City of Ketchum

Agenda Item:	Recommendation to review and approve the Findings of Fact, Conclusions of Law, and Decision for the Knob Hill Residence Lot Consolidation Preliminary Plat Application (P25-16A).
--------------	---

IN RE:)
)
Knob Hill Residence) KETCHUM CITY COUNCIL
Lot Consolidation Preliminary Plat &) FINDINGS OF FACT, CONCLUSIONS OF LAW, AND
Waiver Requests) DECISION
Application File Number: P25-016A)
)
)
Date: March 25, 2026)

PROJECT: Knob Hill Residence
APPLICATION TYPE: Lot Consolidation Subdivision Preliminary Plat with Waiver Requests
FILE NUMBER: P25-016A
ASSOCIATED APPLICATIONS: Pre-Application Mountain Overlay Design Review P24-087 & Mountain
Overlay Design Review P25-016
PROPERTY OWNER: Knob Hill Properties LLC
REPRESENTATIVE: Peter Seidner & Hank Moore, Presidio Vista Properties
ARCHITECT: Zac Rockett, Architect, Ro Rockett Design
REQUEST: Lot Consolidation Subdivision Preliminary Plat with Waiver Request to
consolidate two lots in the LR Zone and establish a building envelope in
25% and greater slope.
LOCATION: Ketchum Townsite—Block 91: Lots 3 & 4
(Parcel Numbers: RPK0000091004A & RPK00000910030)
ZONING: Limited Residential (LR)
OVERLAY: Mountain Overla

Figure 1: Slope Exhibit

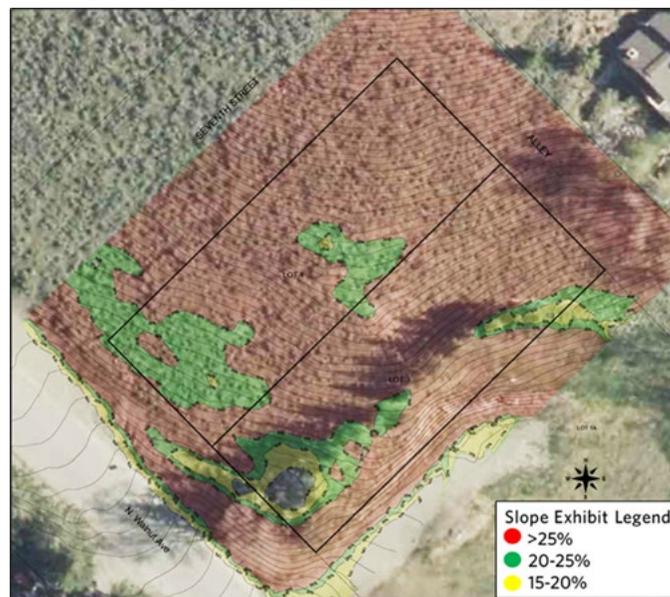
The applicant's presentation included a slope exhibit illustrating that most of the subject property contains hillsides of 25% and greater slope (see Figure 1). The applicant asserts that the subject property is constrained by steep slopes and easements, creating an undue hardship that justifies the requested building envelope waiver. The applicant contends that the proposed design reduces disturbance relative to a two-lot scenario by reducing disturbance, lowering building location, and eliminating the second driveway and represents the most reasonable development option available. The applicant further asserts that the proposed development provides all required infrastructure and drainage improvements.

Council deliberation identified that, although the site is constrained, development enabled by the waivers would require substantial grading, excavation, and alteration of slopes exceeding 25%. Evidence in the record demonstrates that development would disturb a majority of the site and require significant engineered retaining systems to stabilize slopes and manage drainage. The Council further considered concerns related to slope stability and erosion potential. Disturbance of this scale on steep slopes increases the risk of slope instability and erosion, particularly during extreme weather events and seasonal freeze-thaw cycles. These risks are not confined to the subject property and may result in downslope impacts to adjacent properties, public rights-of-way, and infrastructure.

Upon weighing the evidence, the Council finds that while the applicant has demonstrated site constraints sufficient to consider a waiver, the applicant has not demonstrated that the resulting development would avoid detriment to public health, safety, and welfare. The Council finds that development on steep slopes of this magnitude introduces risks associated with slope instability, erosion, and drainage that may affect not only the subject property but also adjacent properties and public infrastructure.
